Lower Hassayampa River Sediment Transport Model Update Summary Final Report

FCD2014C002

Prepared For:
Flood Control District of Maricopa County

Subject: Hassayampa River Sediment Transport Models Update Contract #2014C002/ Summary Final Report (draft) dated May 2015, updated HEC-6, HEC-6T, HEC-RAS, and Fluvial-12 models, and Atkins' updated comment responses dated 6/16/2015 but submitted on 6/25/2015

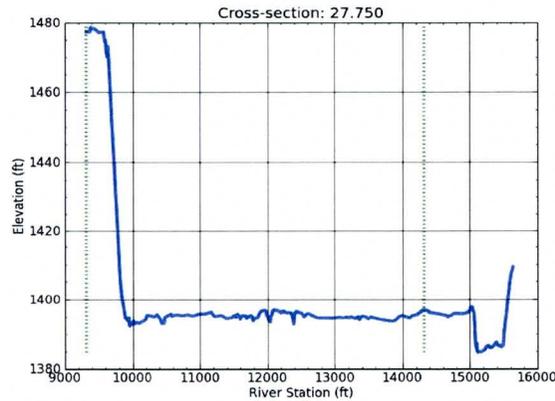
3. **(FCD 2/27/2015)** What do the two vertical dashed green lines in below screen capture represent (photo XS_27.750.png of the Plot/Update HEC-6 folder)? Please note that in the June 2013 HEC-RAS model this cross section has only one ineffective

(Atkins 3-3-2015) Action Taken: The vertical dashed green lines represent channel conveyance limits in the HEC-6 and HEC-6T models. When only one side of the channel requires a conveyance limit, the conveyance limit for the side which does not require a conveyance limit is placed at outer-most station of the cross section. In cross section 27.750 the conveyance limit was moved beyond the limit of a sand and gravel pit to an approximate location of station 15600. A legend has been added to all plots in response to this comment.

(FCD 6/9/2015) Comment resolved.

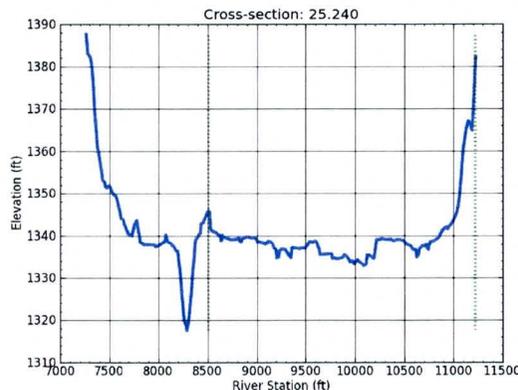
4. **(FCD 2/27/2015)** What does the right-side vertical dashed green line in below screen capture represent (photo XS_25.24.png of the Plot/Update HEC-6 folder)? Please note that in the HEC-RAS cross section there is only one left-side ineffective flow area with starting station at 8507.4 ft.

(Atkins 3-3-2015) Action Taken: The vertical dashed green lines represent channel conveyance limits in the HEC-6 and HEC-6T models. The left-side ineffective flow area in the Stantec HEC-RAS model is modeled in the updated HEC-6 and HEC-6T models using channel conveyance limits since there does not appear to be a berm preventing inundation. The right channel conveyance limit resides at the right-most point in the cross section so that it does not interfere with channel hydraulics of sediment transport. A legend has been added to all plots in response to this comment.

(FCD 6/9/2015) Comment resolved.

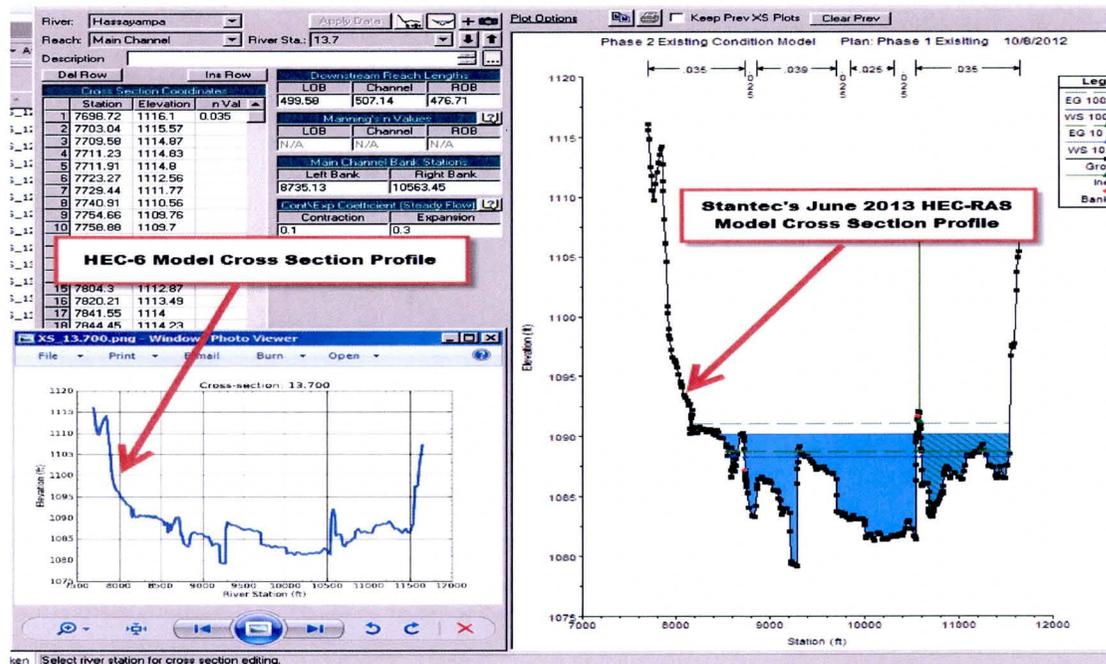
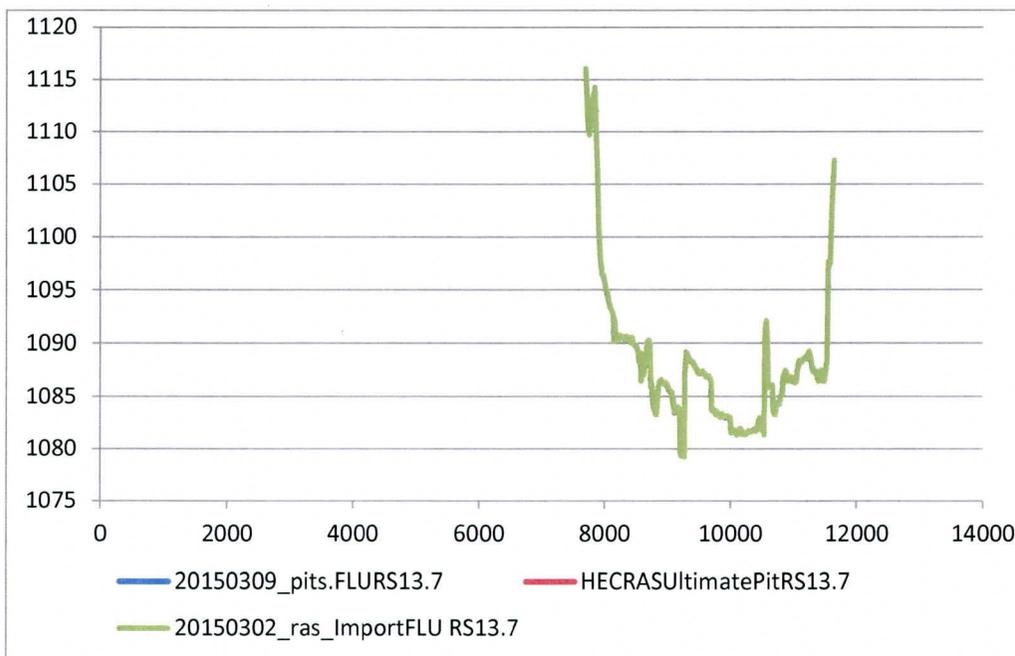
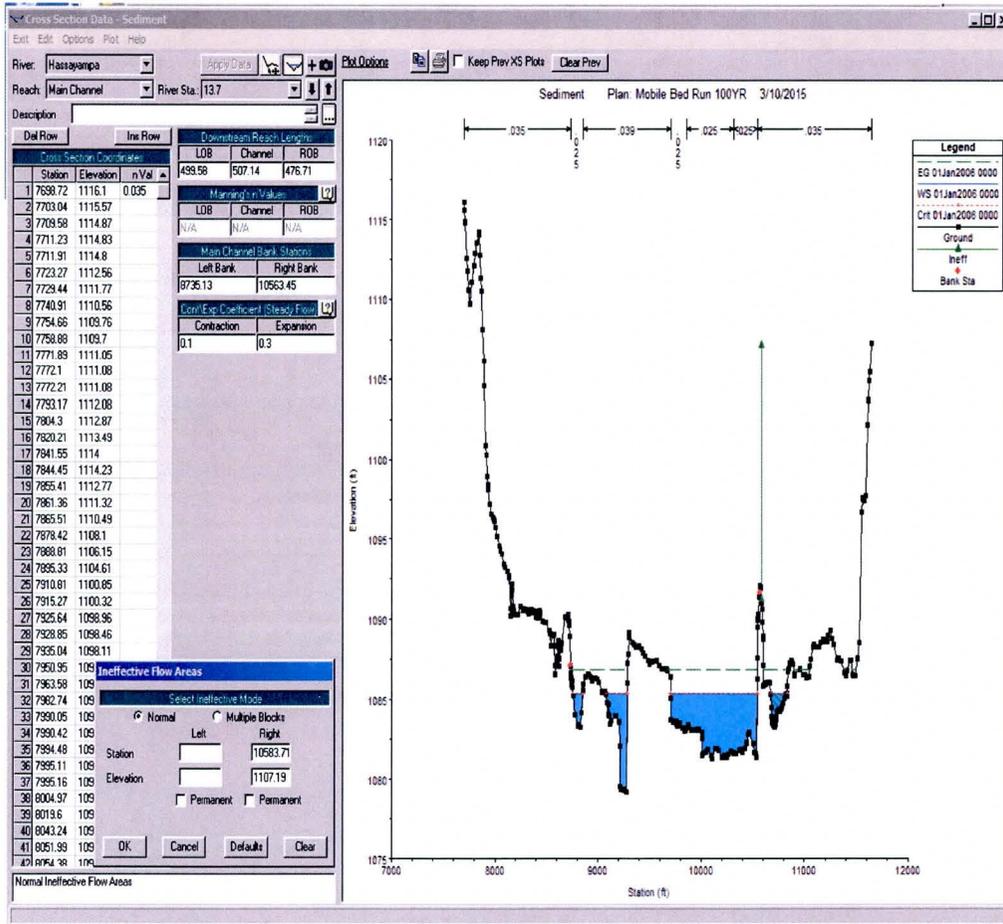
- (FCD 2/27/2015) I did not see an ineffective area vertical line in the HEC-6 model for three cross-sections. But HEC-RAS has ineffective flow lines. It seems that these are not sand and gravel pits. The three cross-sections are XS_13.7, XS_13.610, and XS_13.51. The screen capture below is an illustration of the issue. We assume this is not a pit and the ineffective flow area should be retained in the base HEC-6 model.

(FCD 3/20/2015) Below screen capture shows the HEC-RAS ultimate pit sediment transport model includes an ineffective flow area in cross section RS 13.7 as the Stantec's 2013 HEC-RAS hydraulics model did (which is good). However, as shown in another screen capture that follows the below screen capture, the updated Fluvial-12 base and ultimate pit models do not reflect this

ineffective area in their cross section RS 13.7 (which may not be good because the Fluvial-12 and HEC-RAS models become inconsistent in their cross section profiles).

(Atkins 5-27-2015) Action Taken: Previously, only ineffective flow areas (not channel conveyance limits) from the HEC-6 model were reflected in the Fluvial-12 cross sections. The Fluvial-12 model has been updated so that the cross section geometry now reflects both the ineffective flow area and channel conveyance limits present in the HEC-6 model.

FCD (6/9/2015) Okay, Comment resolved.

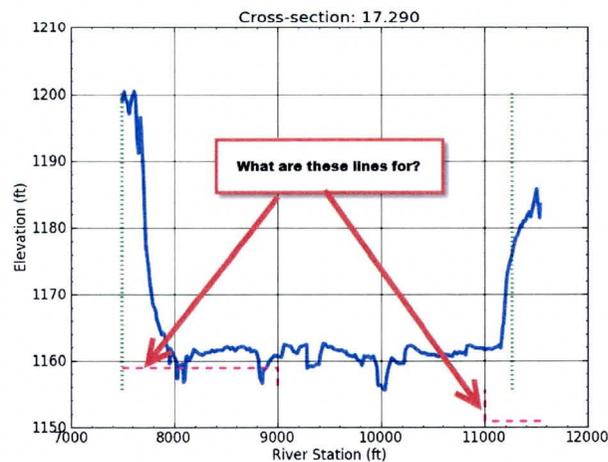
6. **(FCD 2/27/2015)** What are those purple lines in the HEC-6 cross section profile photos? An example of these cross section profile photos is shown below.

(Atkins 3-3-2015) Action Taken: The dashed purple lines represent ineffective flow areas in the HEC-6 and HEC-6T models. A legend has been added to all plots in response to this comment.

(Atkins 5-27-2015) NOTE: If one ineffective flow area is needed in the model, an ineffective flow area for both the left and right sides of the channel must be present for HEC-6 to run, therefore any unused ineffective flow areas (ones which are below the cross section and never intersect the cross section) have been moved to the extreme edge of the cross section.

(FCD 6/9/2015) Okay. Comment resolved.

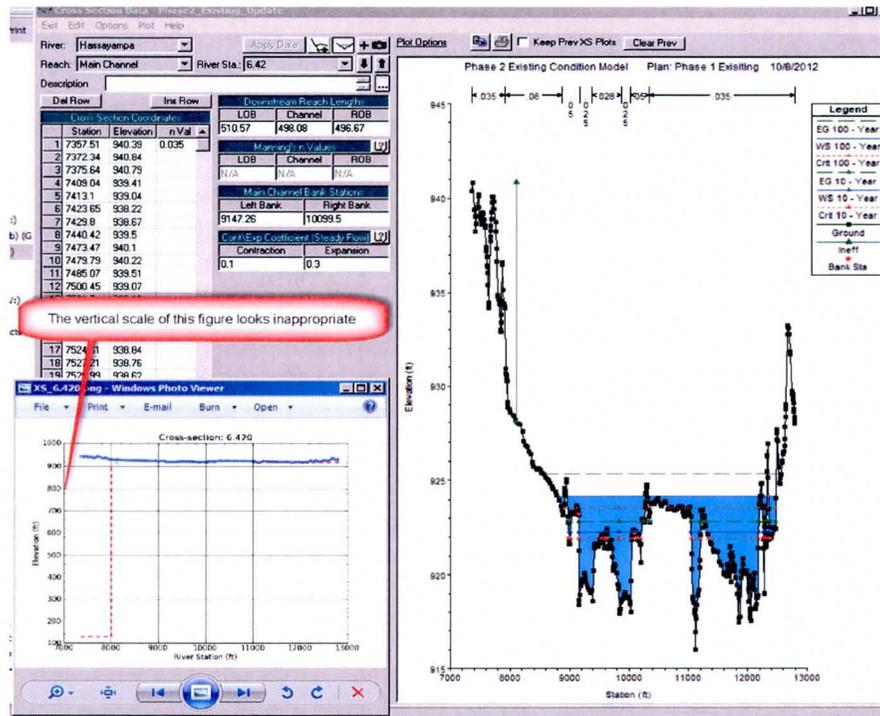
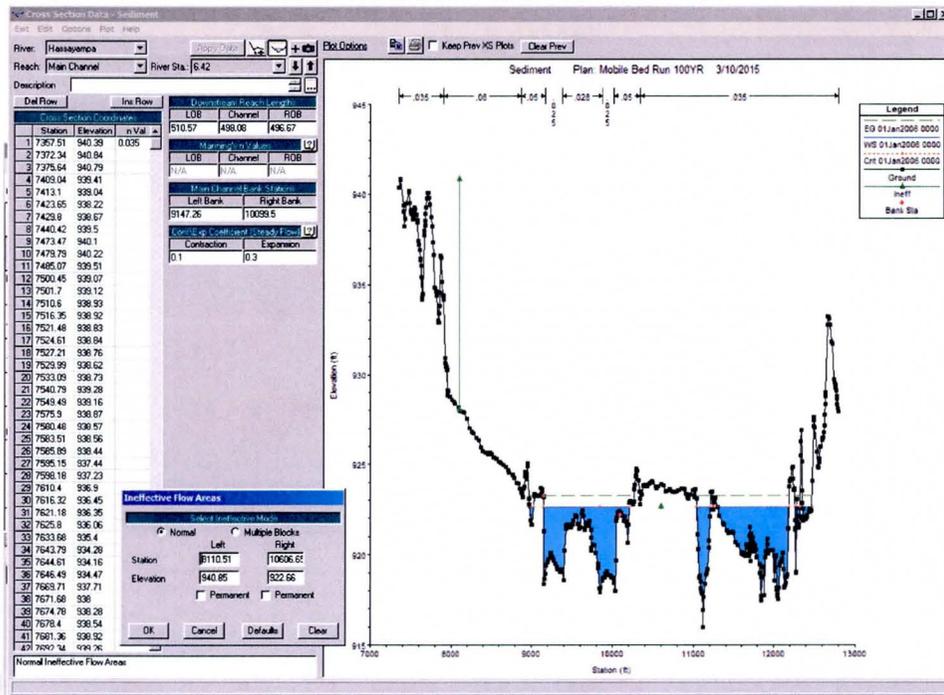
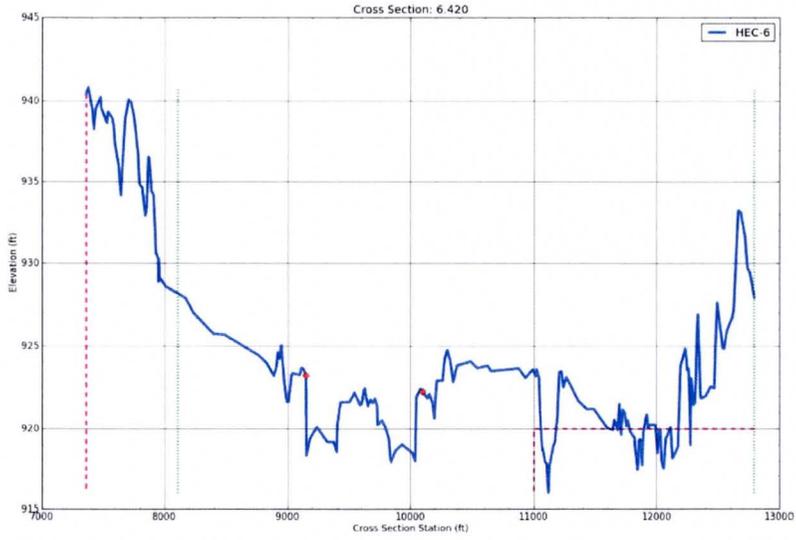
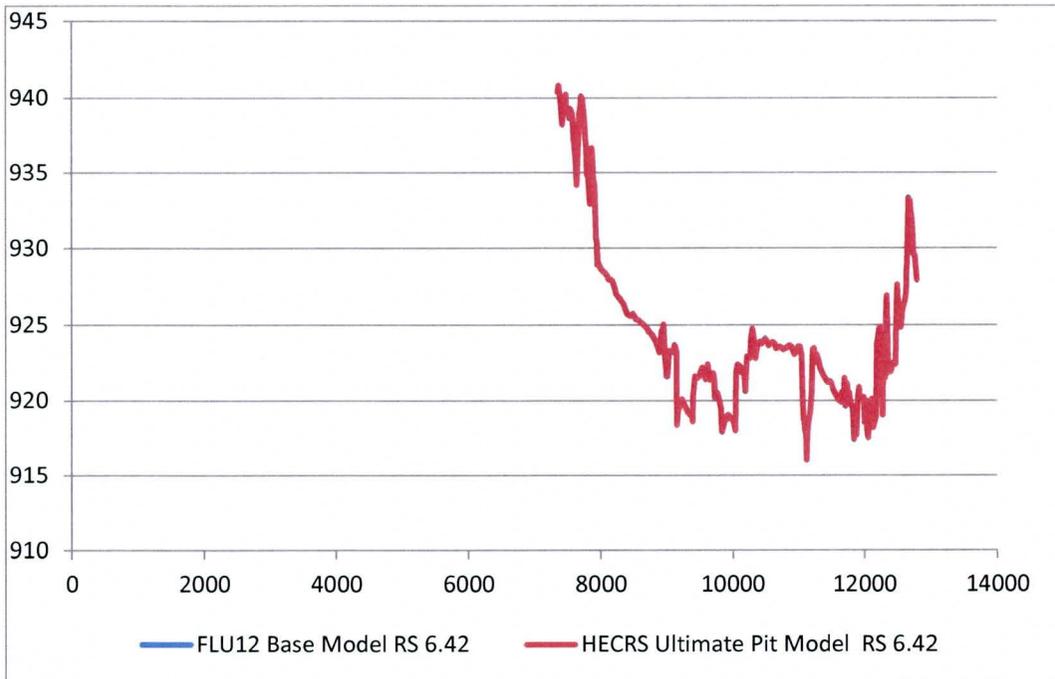
7. **(FCD 2/27/2015)** The vertical/horizontal scale in following cross section profile photos (HEC-6 base model) appears inappropriate: XS_23.920.png, XS_23.630.png, XS_23.540.png, XS_22.880.png, XS_6.420.png, XS_6.230.png. An example of these photos is shown below.

(FCD 3/20/2015) The figures/figure scales have been changed as shown in below screen capture, which is good. However, some discrepancies in ineffective flow area, conveyance limit, and encroachment between the models are shown in the two screen captures that follow the below screen capture. The two screen captures show that HEC-RAS model includes left and right ineffective areas, HEC-6 model includes conveyance limits and encroachment, and Fluvial-12 model does not reflect the ineffective flow areas. Please discuss how these discrepancies will impact the modeling results.

(Atkins 3-3-2015) Action Taken: The vertical and horizontal scale of these plots is determined by the location of the cross section points, the two points dictating ineffective flow areas, and channel conveyance limits. To avoid errors, the left and right points determining the location of ineffective flow must be included in the HEC-6 model. When only one point of the ineffective flow was necessary in the JE Fuller HEC-6 model, the other was placed below the cross section. In the case of the aforementioned cross sections they were placed hundreds of feet below the cross section. The plots generated are scaled to show all relevant data. To resolve this problem, a point representing an ineffective flow area which is present, but not in use, is moved to the station and elevation of the outermost point on the corresponding side of the cross section.

(Atkins 5-27-2015) Action Taken: In HEC-6 and HEC-6T, ineffective flow areas are used to alter the cross section geometry prior to performing any hydraulic and sediment transport modeling (similar to editing the cross section in Fluvial-12), whereas conveyance limits define the limits of erosion. Erosion may not occur outside of the conveyance limits, however, deposition may still occur outside the conveyance limits. Conveyance limits and ineffective flow areas were using in accordance with what had been used in the original 2006 JE Fuller HEC-6 model.

FCD (6/9/2015) Okay, comment resolved.

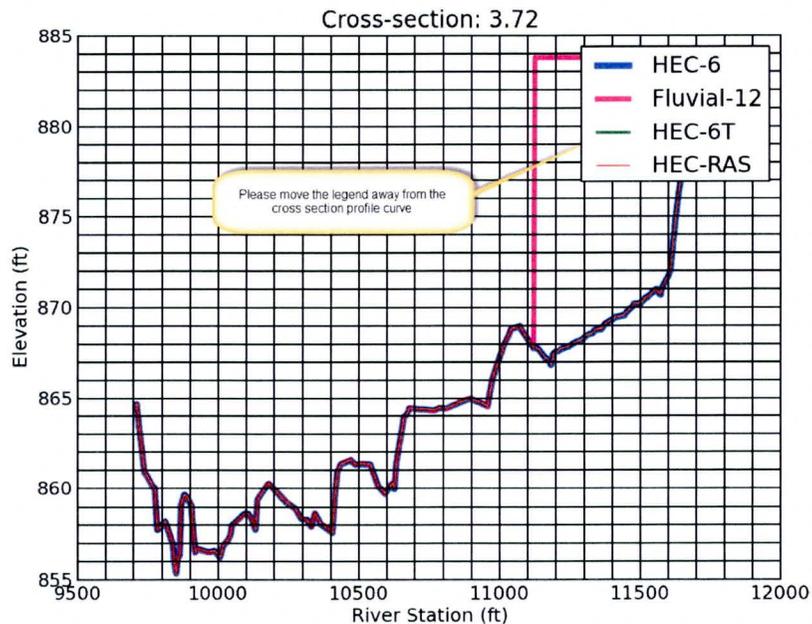
- (FCD 2/27/2015)** For the photos in the “Updated Models –HEC-RAS, HEC-6, HEC-6T, Fluvial-12” folder, please move the legend away from the cross section profiles curves (see the screen capture below for an example).

(Atkins 3-3-2015) Action Taken: Previously the legends appeared at the top right corner of each plot. Now all legends have been placed in the most suitable location.

(FCD 3/20/2015) Okay. Comment resolved.

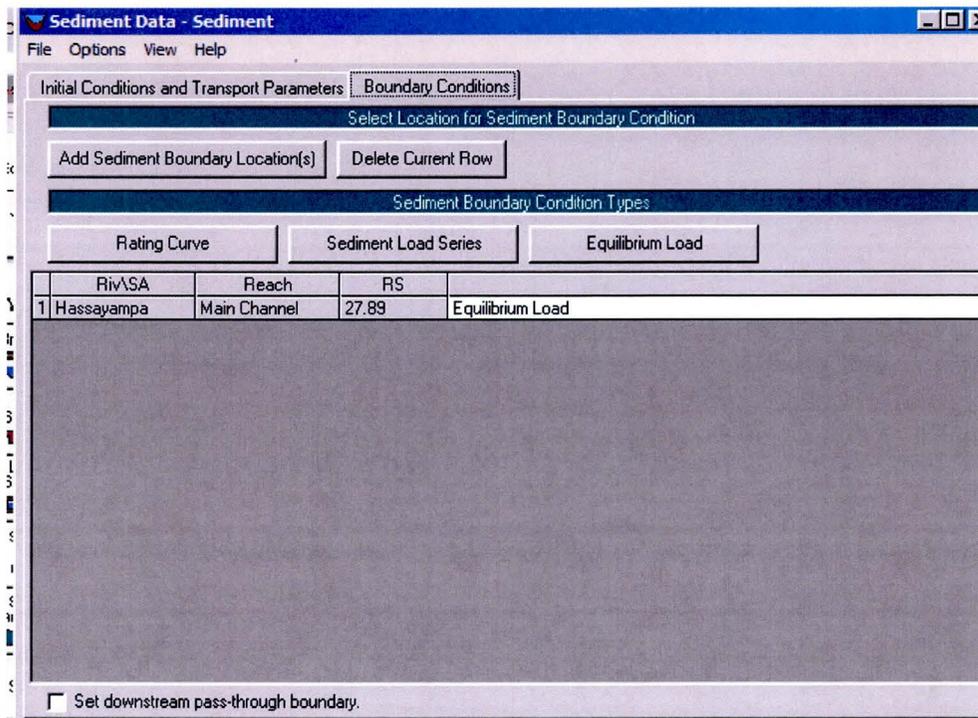
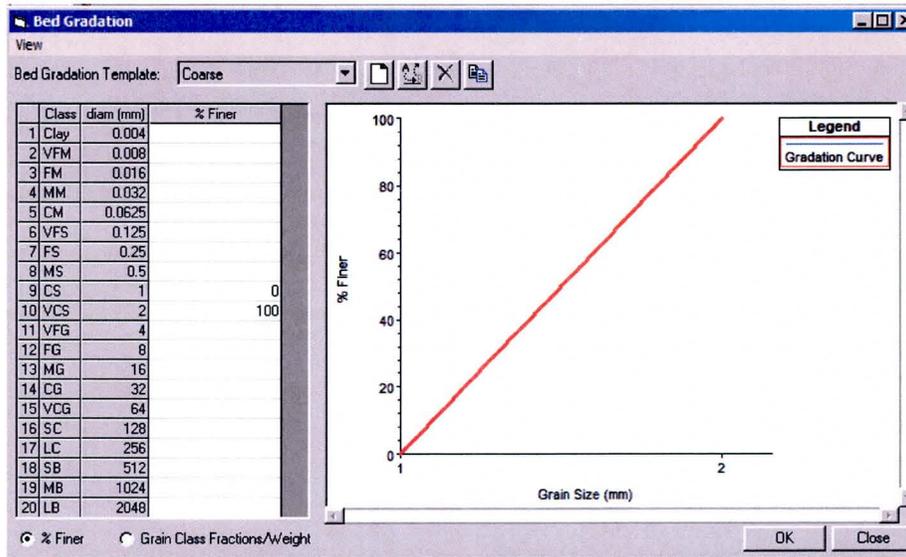
9.**(FCD 3/20/2015)** In the HEC-RAS sediment transport models the initial sediment gradations and the upstream sediment inflow load (shown in below screen captures) are not the same as those in the JE Fuller's 2006 HEC-6 model. Please revise these to be consistent with the JE Fuller's 2006 HEC-6 model.

(Atkins 5-27-2015) Action Taken: Sediment load at the upstream boundary has been set to match the 2006 JE Fuller HEC-6 model. The HEC-RAS gradation has been changed to match the 2006 JE Fuller HEC-6 model.

FCD (6/9/2015) Okay, Comment resolved.

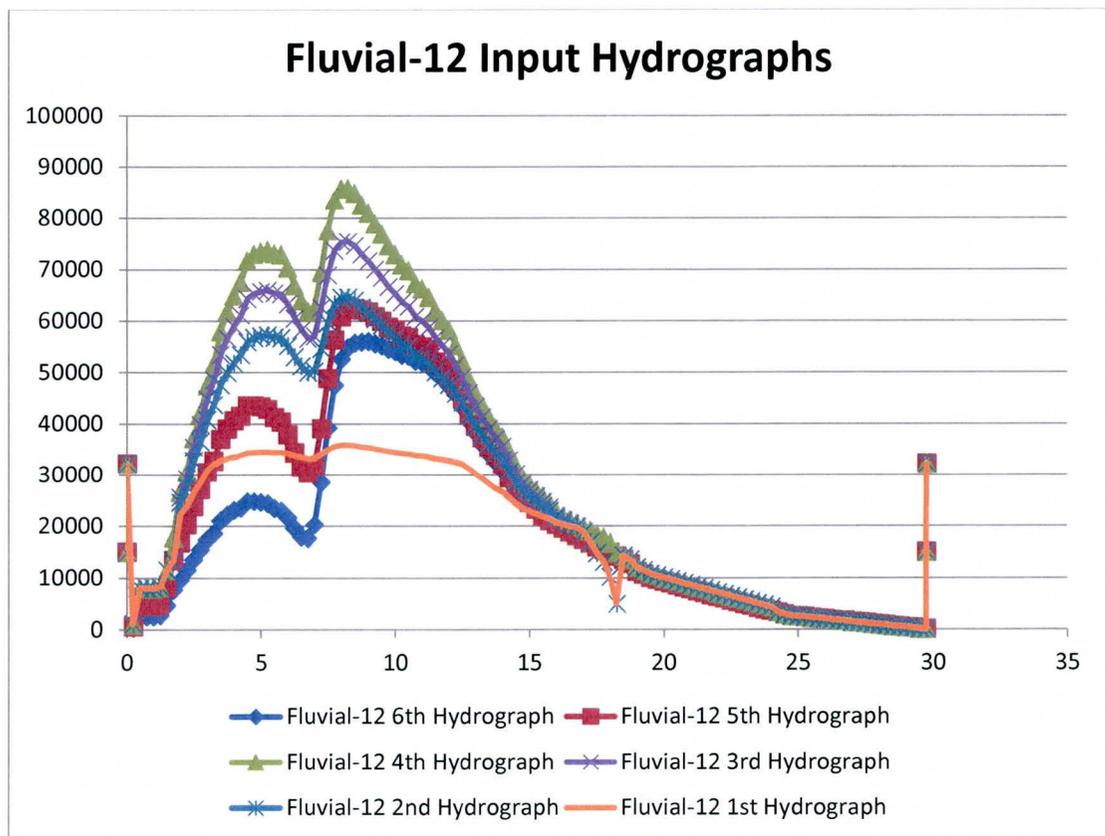
(FCD 6/9/2015) Below figure shows the six input hydrographs for the Fluvial-12. Please explain why the hydrographs have sharp spikes at time 0 hour and time 30 hour (see figure below) (we did not see these two spikes in the 100-year hydrograph of JE Fuller's HEC-6 model).

(Atkins 6-25-2015) We have removed these spikes. They are artifacts of near instantaneous 10-year events used for output recording purposes in JE Fuller's HEC-6 model. We have also used linear interpolation to eliminate the dip in the first hydrograph in the image below.

(Atkins 6-30-2015) The spikes and dips have been removed in all affected hydrographs.

(FCD 6/30/2015) The spikes and dips have been removed in all affected hydrographs. Comment resolved.

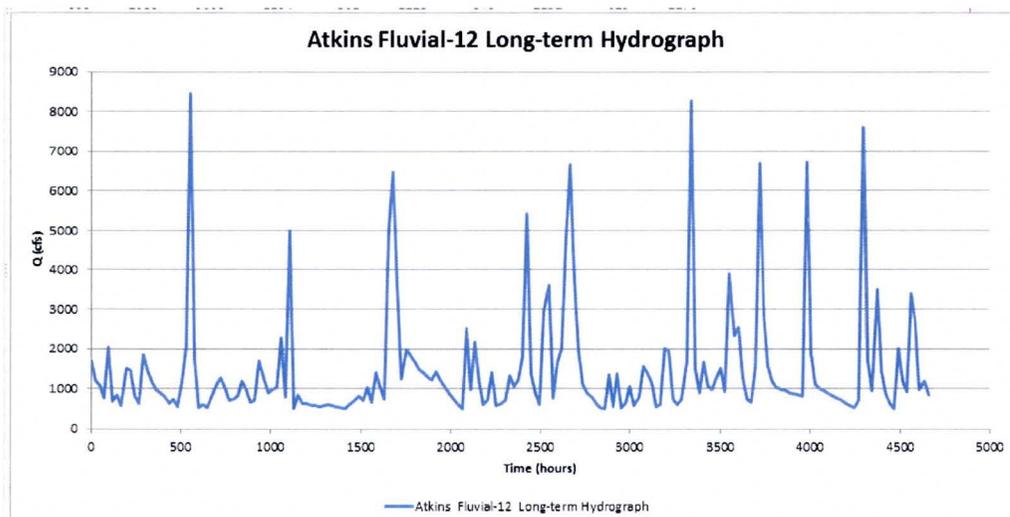
- (FCD 3/25/2015)** In the JE Fuller's long term HEC-6 model, the hydrograph is different in these three reaches: from RS 27.89 to RS 21.08, from RS 21.08 to RS 15.21 and from RS 15.21 to RS 0.35 (there are local inflows at RS 21.08 and RS 15.21). However, in Atkins long term Fluvial-12 model, one hydrograph appears to cover the entire river reach from RS 27.89 to RS 0.35 (which is shown in below screen capture). Please revise these to be consistent with the JE Fuller's 2006 HEC-6 model.

(Atkins 5-27-2015) Action Taken: We have replaced the hydrograph from the original 2009 Chang model with the hydrograph from the 2006 HEC-6 model by JE Fuller.

(FCD 6/9/2015) Okay. Comment resolved.
